ASSESSMENT REPORT

Section 75W Modification Pasminco and Incitec Consolidated Remediation, Boolaroo (MP 06_0184 MOD 4 & MP 08_0221 MOD 1)

Figure 4: Likely view of the site and containment cell from the entry road with approved cell modifications.

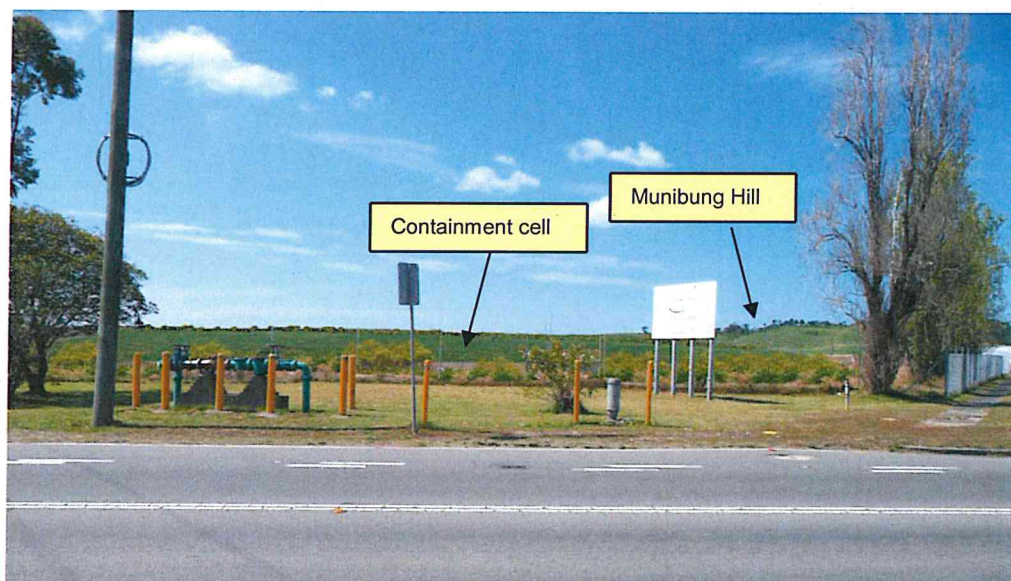
However, in its submission, Council raised concerns about the visual impact of the proposed modifications, particularly that the 'relieving amelioration measures previously approved have decreased'. Key concerns raised were that trees would no longer be planted on the perimeter of the cell platform and batters, and the proposed modifications would increase the height of the cell.

In its response to submissions, Pasminco confirmed that the trees have been removed from the proposed landscaping predominantly due to a change in the depth available for planting in the cell cap layer. This altered depth is a result of the previously approved modification where the amount of total clay in the cap had been reduced (600mm to > 100 mm).

Notwithstanding, Pasminco considers that amelioration measures can still be implemented with shallow root bearing shrubs and native grasses on the cell's batters and top surface while larger trees can be considered at the base of the cell for screening purposes if desirable. Informal groves of trees could be planted at the base of the cell with avenue planting along the cell's perimeter roads as the base of the cell has greater opportunity for deep soil planting to occur.

Regardless, Pasminco is required to prepare a Landscape Management Plan in consultation with Council (in accordance with existing condition 8.7(c)) prior to the completion of remediation. This condition also requires Pasminco to consider on-going maintenance for the permanent vegetation cover on the cell.
